# City of Santa Barbara California

## PLANNING COMMISSION STAFF REPORT

**REPORT DATE:** December 20, 2007  
**AGENDA DATE:** January 10, 2008  
**PROJECT ADDRESS:** 1236 San Andres Street (MST2006-00364)

SITE PLAN

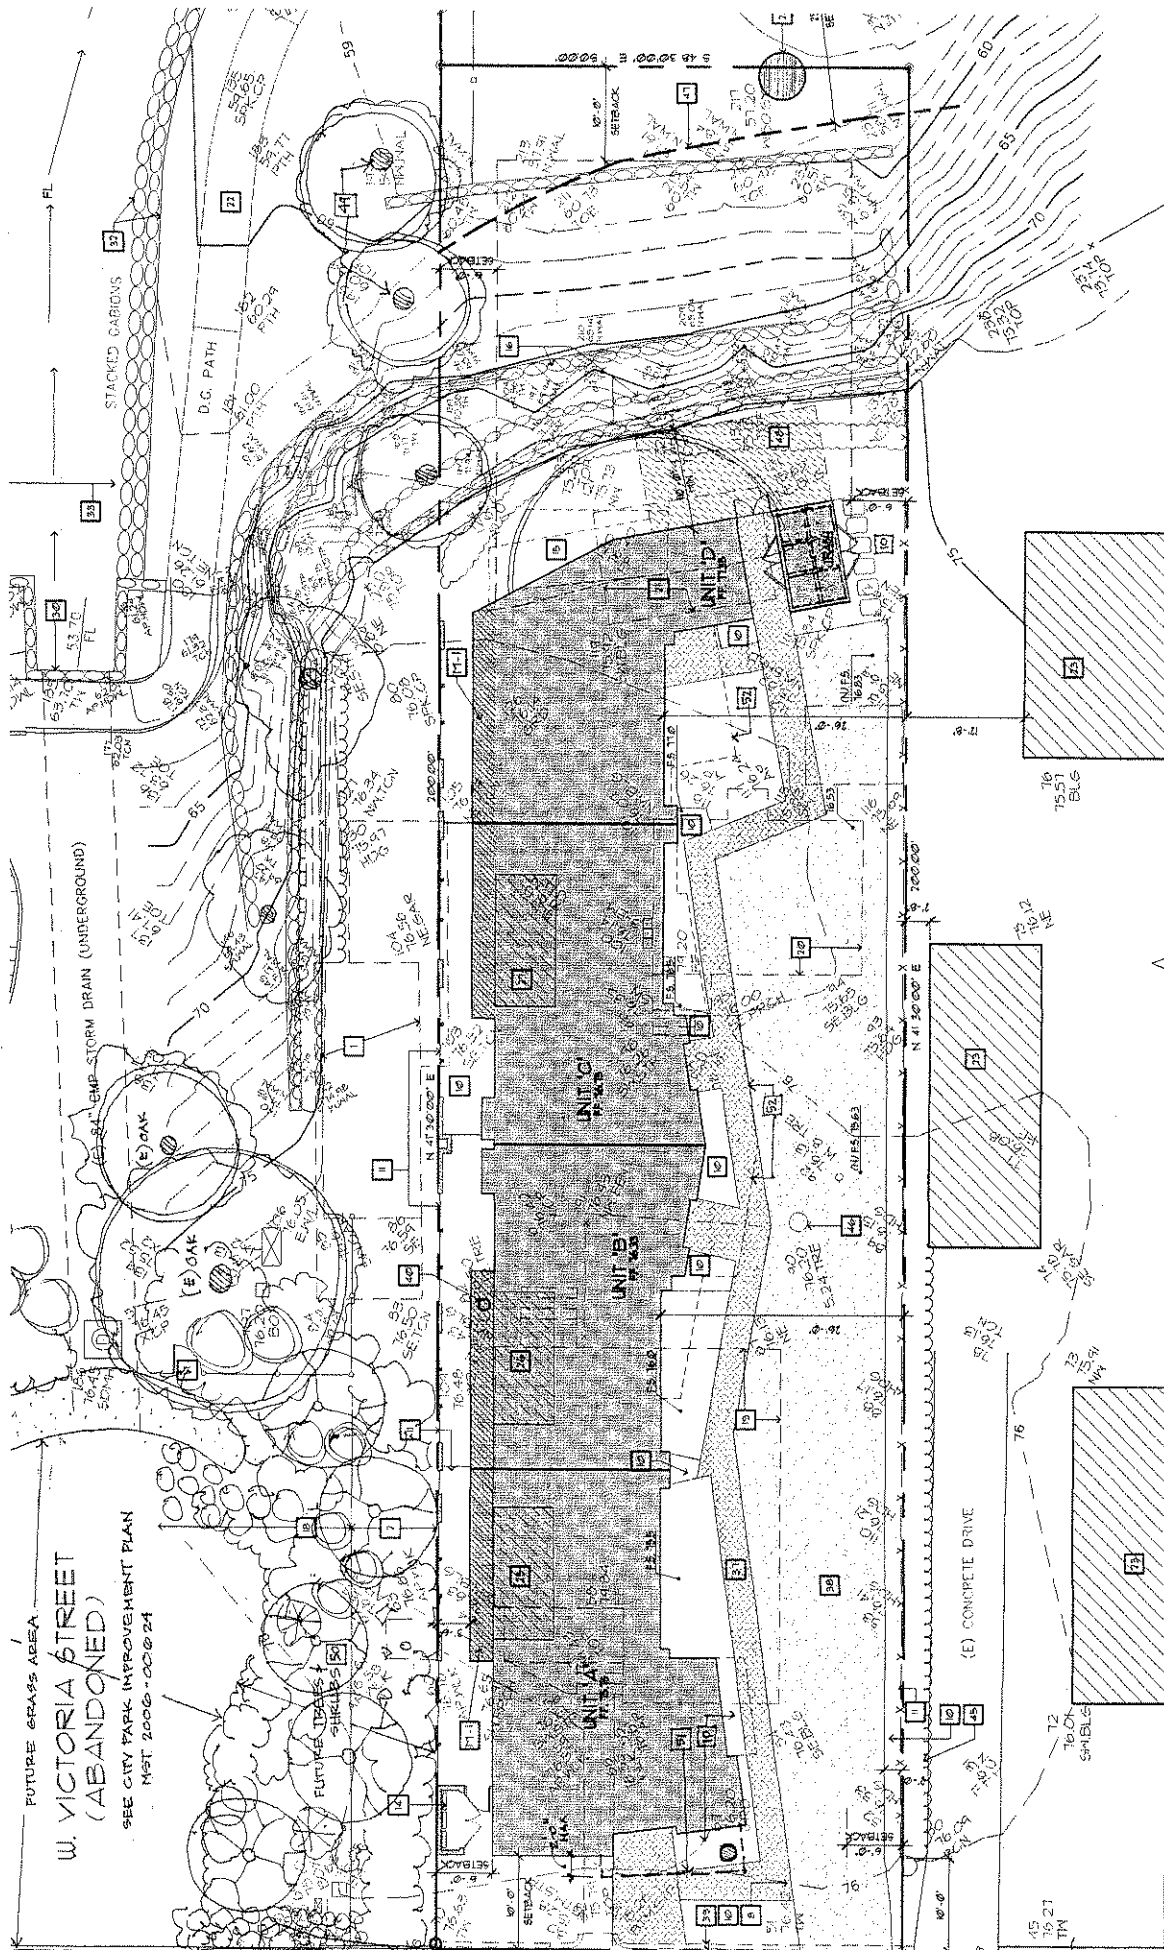
In addition to the ABR comments, staff expressed concern about the width of the parapet on the second floor adjacent to the patio. The main concern is the parapet, which is located within the required interior yard setback, is fairly wide and flat and could be used as a counter surface. Therefore, we have included language in the design review condition that the applicant continues to work with the ABR to design the parapet as an architectural element, rather than a usable area associated with the patio.
